(608) 255-5656
JEFFERSON COUNTY
LAW ENFORCEMENT CENTER
JEFFERSON, WISCONSIN
FIRST FLOOR PLAN
1/8"=1'-0"
Jul-94
A6
AS BUILT
DEC 6, 1994

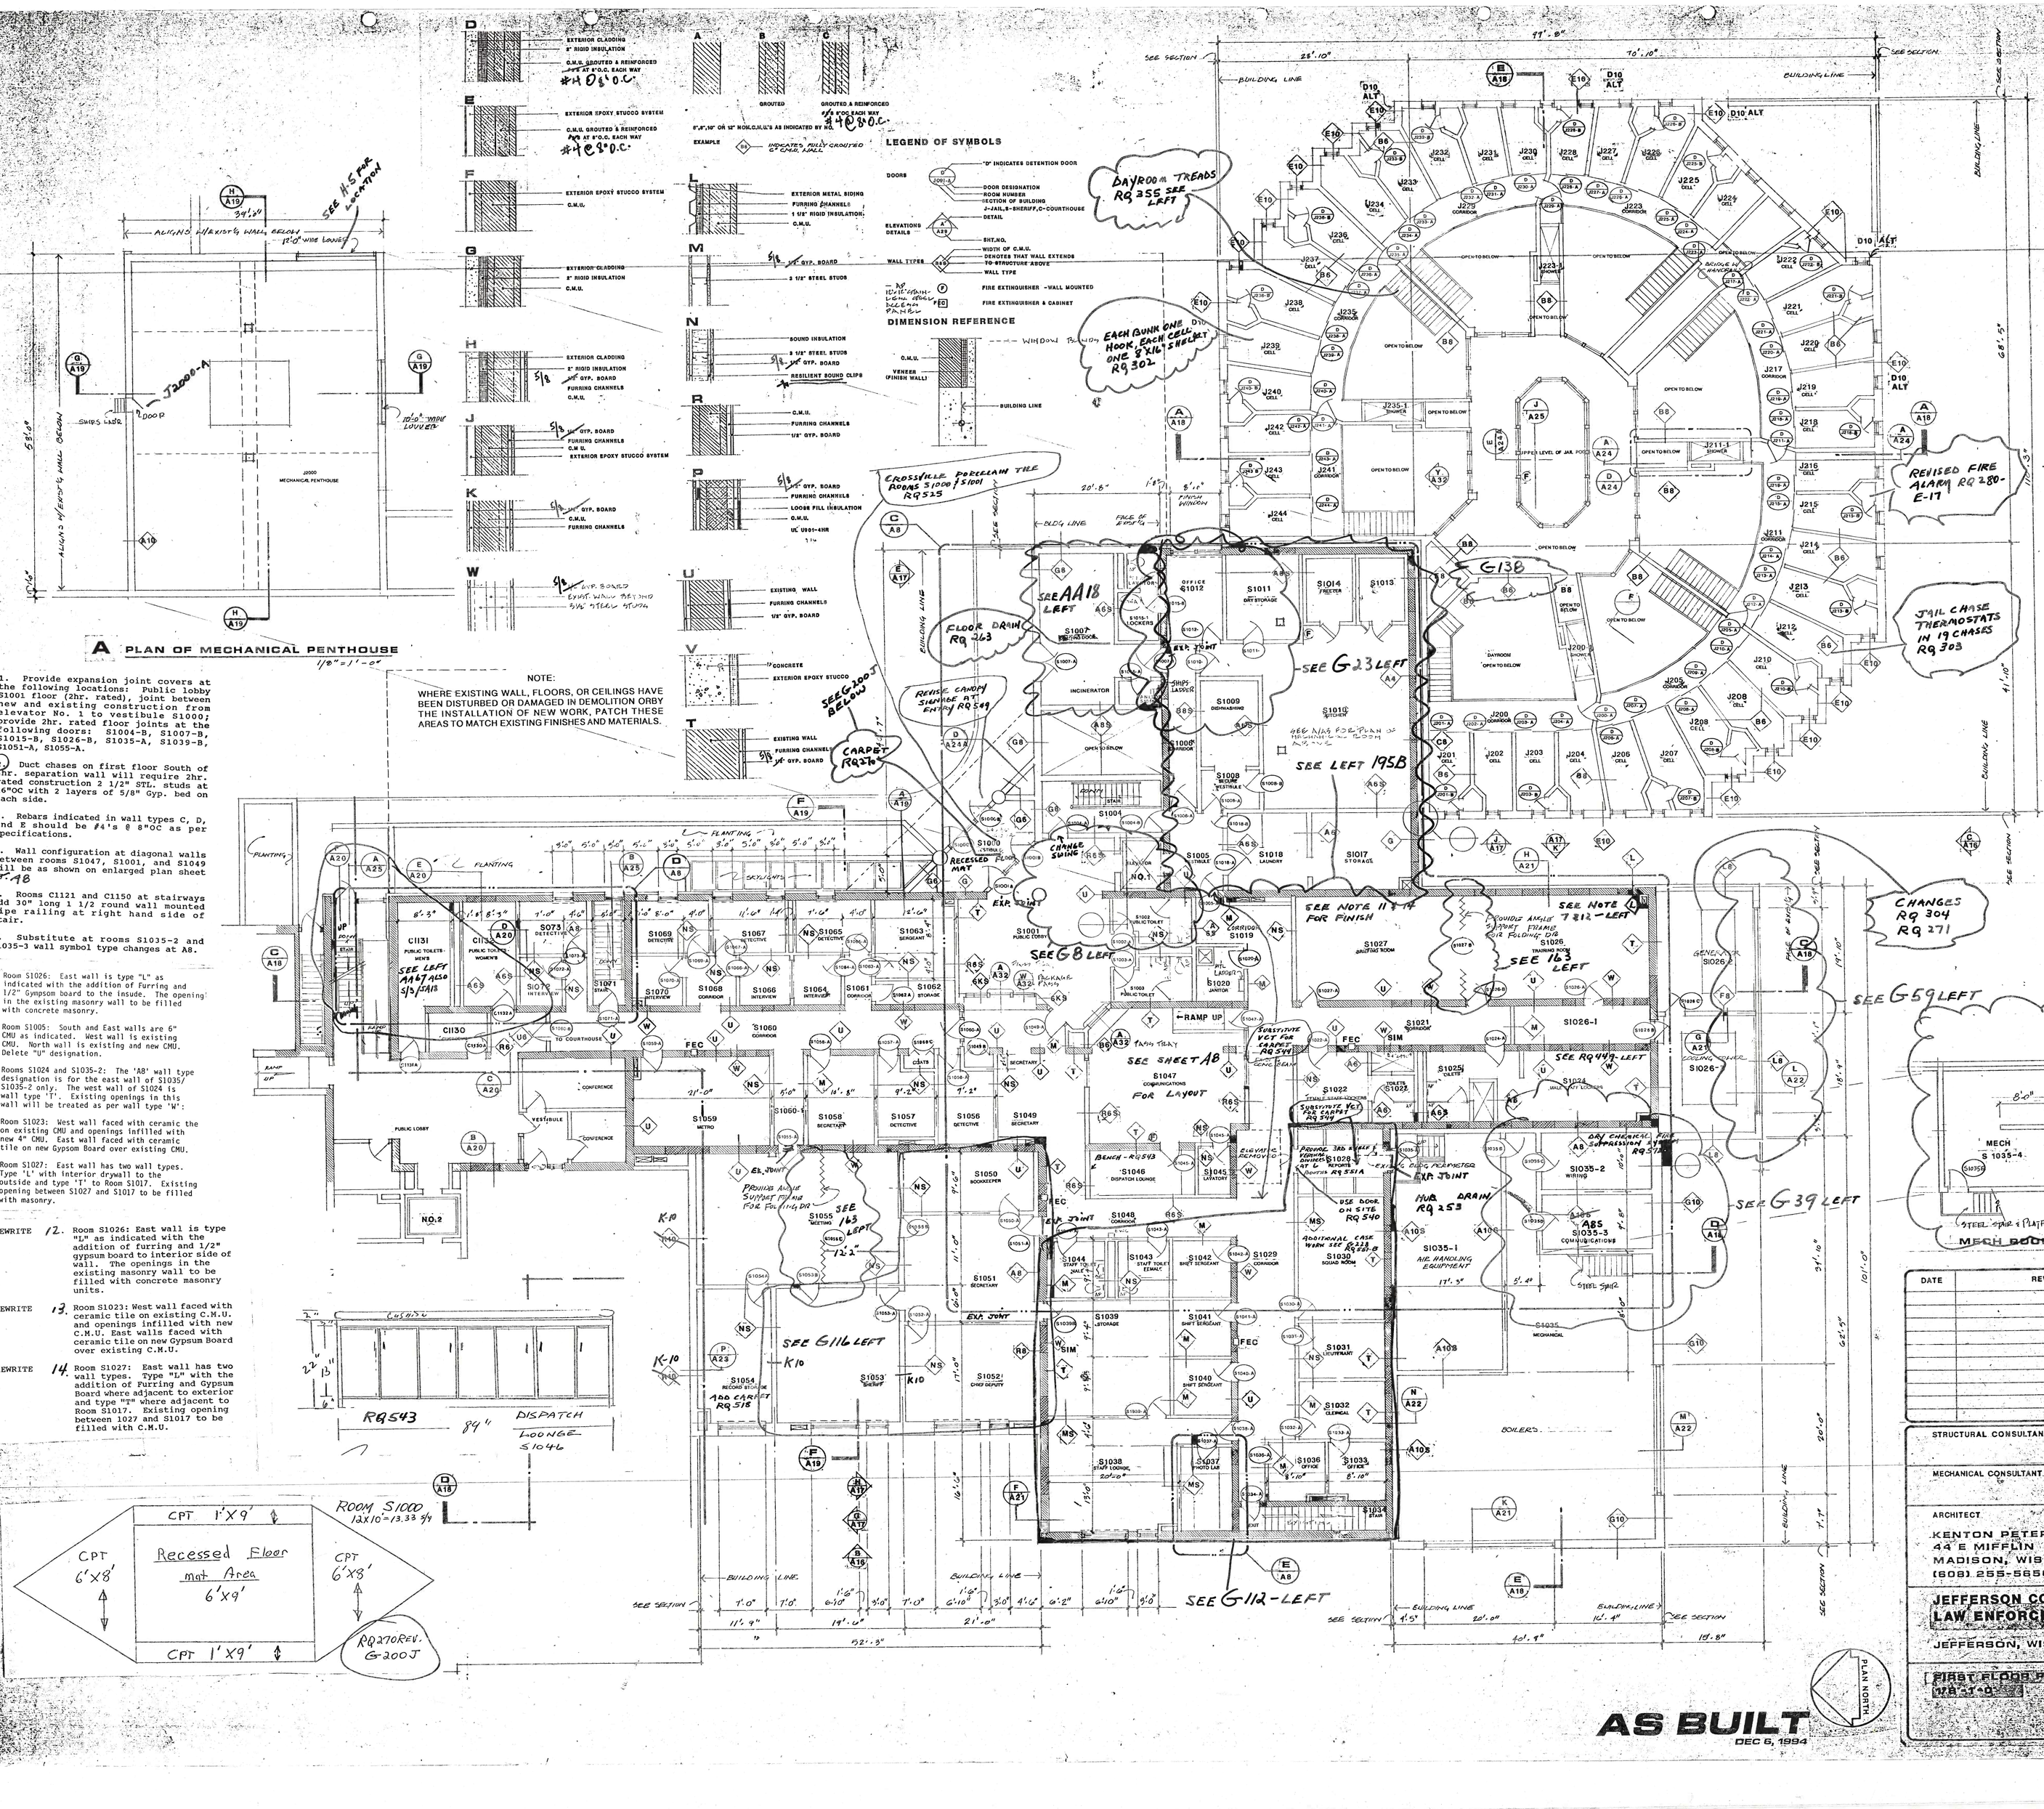
1. Provide expansion joint covers at the following locations: Public lobby S1001 floor (2hr. rated), joint between new and existing construction from elevator No. 1 to vestibule S1000; provide 2hr. rated floor joints at the following doors: S1004-B, S1007-B, S1015-B, S1026-B, S1035-A, S1039-B, S1051-A, S1055-A.

2. Duct chases on first floor South of 4hr. separation wall will require 2hr. rated construction 2 1/2" STL. studs at 16"OC with 2 layers of 5/8" Gyp. bed on each side.

3. Rebars indicated in wall types C, D, and E should be #4's @ 8"OC as per specifications.
4. Wall configuration at diagonal walls between rooms S1047, S1001, and S1049 will be as shown on enlarged plan sheet A8

5. Rooms C1121 and C1150 at stairways add 30" long 1 1/2 round wall mounted pipe railing at right hand side of stair.
6. Substitute at rooms S1035-2 and S1035-3 wall symbol type changes at A8.

7. Room S1026: East wall is type "L" as indicated with the addition of furring and 1/2" Gympsum board to the inside. The opening in the existing masonry wall to be filled with concrete masonry.

8. Room S1005: South and East walls are 6" CMU as indicated. West wall is existing CMU. North wall is existing and new CMU. Delete "U" designation.
9. Rooms S1024 and S1035-2: The 'AB' wall type designation is for the east wall of S1035/ S1035-2 only. The west wall of S1024 is wall type 'I'. Existing openings in this wall will be treated as per wall type 'W':

10. Room S1023: West wall faced with ceramic the on existing CMU and openings infilled with new 4" CMU. East wall faced with ceramic tile on new Gypsom Board over existing CMU.

11. Room S1027: East wall has two wall types. Type 'L' with interior drywall to the outside and type 'I' to Room S1017. Existing opening between S1027 and S1017 to be filled with masonry.
REWRITE 12. Room S1026: East wall is type "L" as indicated with the addition of furring and 1/2" gypsum board to interior side of wall. The openings in the existing masonry wall to be filled with concrete masonry units.
REWRITE 13. Room S1023: West wall faced with ceramic tile on existing C.M.U. and openings infilled with new C.M.U. East walls faced with ceramic tile on new Gypsum Board over existing C.M.U.
REWRITE 14. Room S1027: East wall has two wall types: Type "L" with the addition of Furring and Gypsum Board where adjacent to exterior and type "I" where adjacent to Room S1017. Existing opening between 1027 and S1017 to be filled with C.M.U.
NOTE: WHERE EXISTING WALL, FLOORS, OR CEILINGS HAVE BEEN DISTURBED OR DAMAGED IN DEMOLITION ORBY THE INSTALLATION OF NEW WORK, PATCH THESE AREAS TO MATCH EXISTING FINISHES AND MATERIALS.

SEE G59 LEFT
SEE G38 LEFT
SEE G39 LEFT
SEE SHEET A8
SEE G6 LEFT
SEE G116 LEFT
SEE G112 - LEFT
SEE RQ449 - LEFT
SEE 163 LEFT
RQ543
DISPATCH LOUNGE S1046
ROOM S1000 12X10'-13.33 SY
CPT 1'X9' CPT 6'X8' Recessed Floor mat Area 6'x9' CPT 6'X8' CPT 1'X9'
RQ270 REV. G200J
MECH S 1035-4
STEEL STAIR & PLATFORM
MECH ROOM ABOVE S1035-2 & 1035-3
DATE REVISION
STRUCTURAL CONSULTANT
MECHANICAL CONSULTANT
ARCHITECT
KENTON PETERS & ASSOC. INC.
44 E MIFFLIN
MADISON, WISCONSIN 53703
